REMARKS

This paper responds to the Office Action mailed December 5 2003.

FIG 1 PRIOR ART

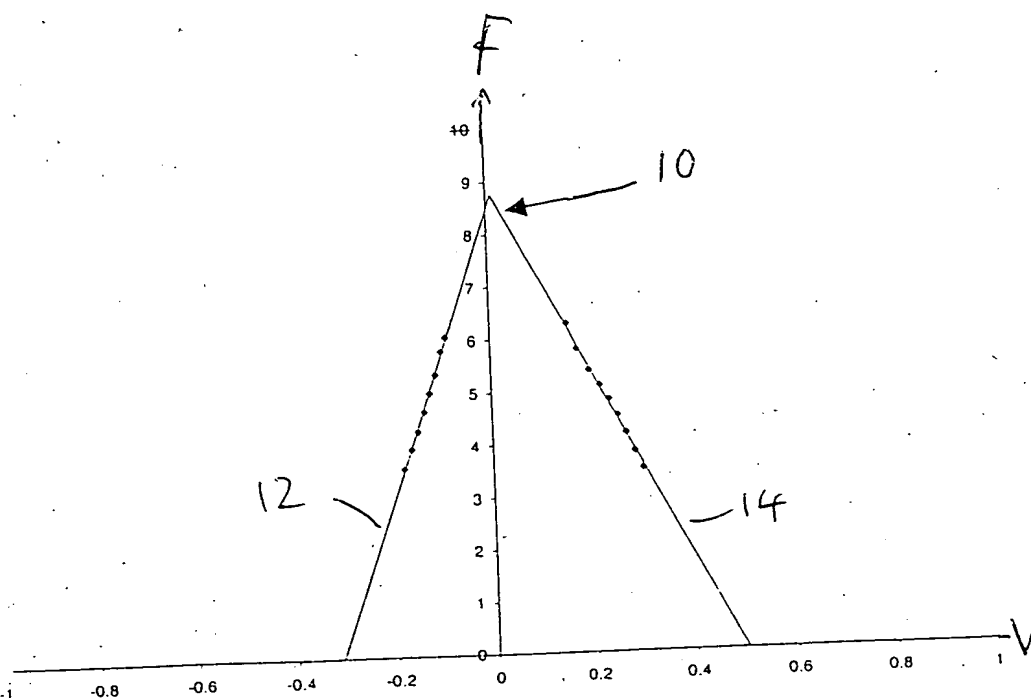
With regard to the objections to the drawings, new pages 1 and 6 of the drawings accompany this response. Figures 1 and 2 are labelled as prior art, and a box "control" has been added to Figure 7 which provides the " V_{VARIABLE} " decision threshold.

The amendment to the specification is to correct an error. The correct formula appears in Figure 1.
